## **Planning Commission Staff Report: Site Plan STP2011-00085, Rollins Center**

**MEETING DATE:** November 9, 2011

**APPLICATION DESCRIPTION:** Proposal to develop a 9,272 square foot one (1) story commercial building that will consist of approximately 6,288 square feet of retail space and approximately 2,984 square feet of office space. On the west (rear) side of the building will be a one (1) lane drive -thru bank. The applicant is also requesting waivers from Section 4 of the Landscaping, Screening and Lighting Manual and from Section 25.17.03 of the Zoning Ordinance from the Screening and Placement of Utility Equipment.

ATTACHMENT 5-3

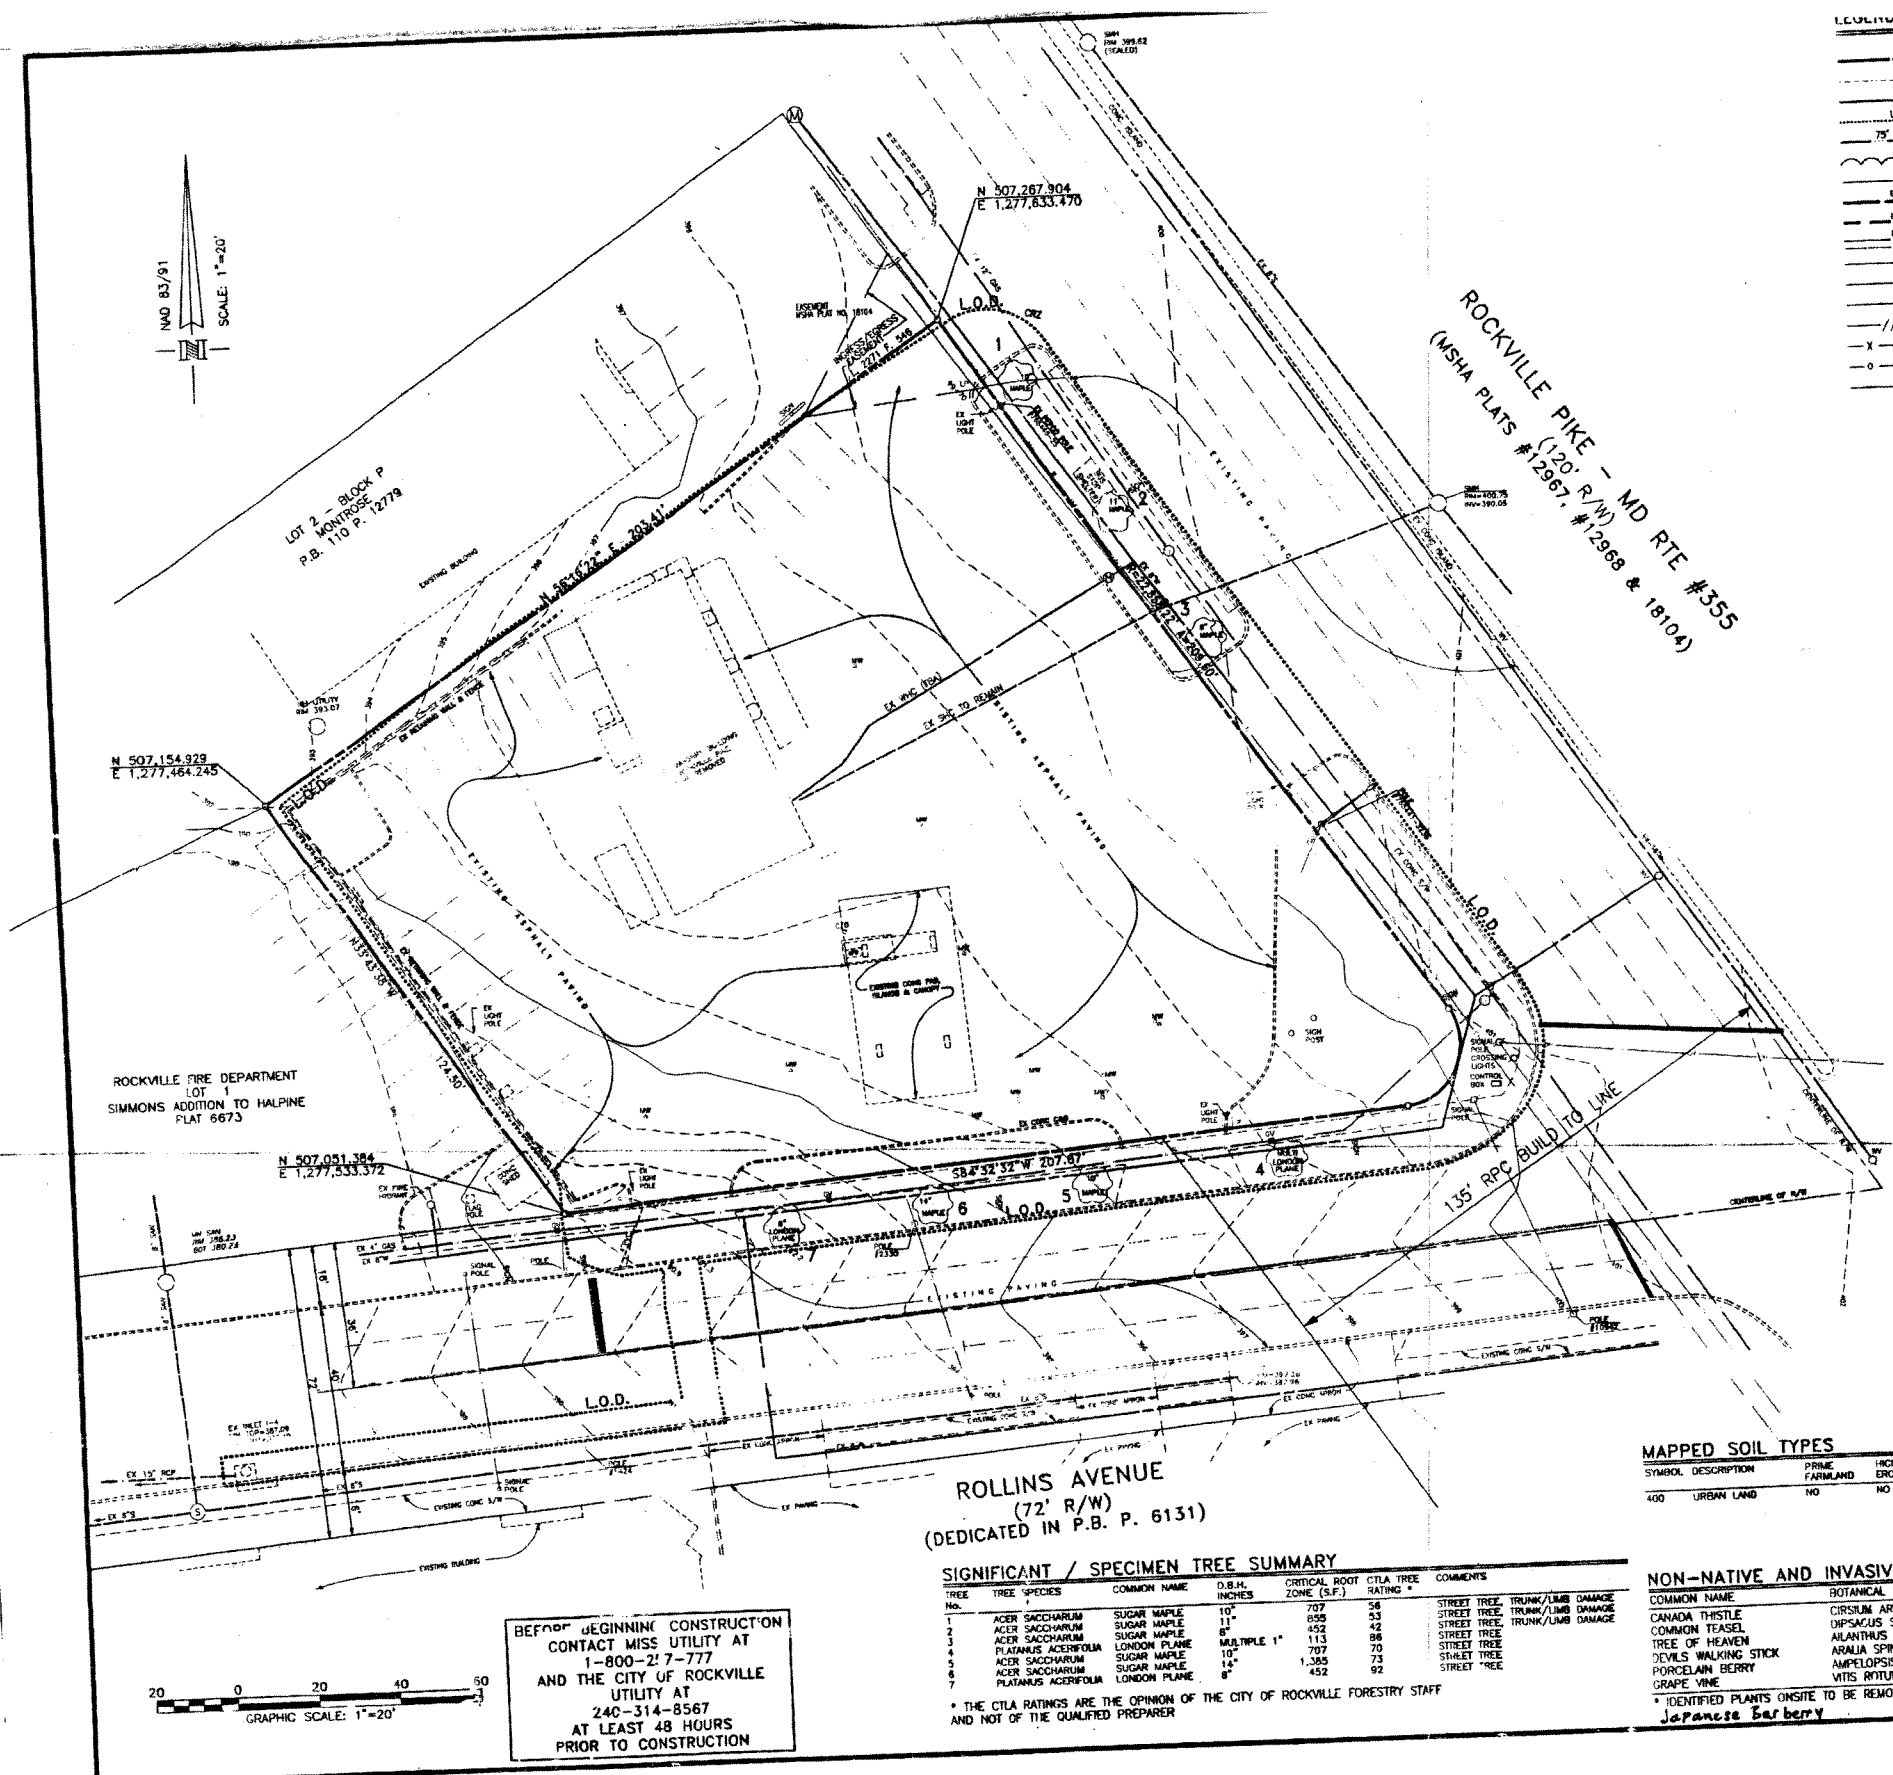
1. The Rock Creek sewershed cannot adequately provide the necessary sewer service for this project. However, the existing 8-inch main in the Cabin John sewershed can.

2. The existing 8-inch public water main along Rollins Avenue is adequate to provide necessary water service for this project; however, the fire protection is not adequate. The existing fire hydrant located along Rollins Avenue provides inadequate flow of less than 1,000 gpm.

- a. Replace the existing hydrant and lead pipe to achieve fire flow greater than 2,000 gpm, which is adequate for this planning zone. The exact location will be determined during detailed engineering review.

- d. Establish an easement for the water meter serving the site. No landscaping may be planted within the water meter easement.
3. Submit water and sewer construction documents to DPW for review, approval and permitting at the detailed engineering stage.
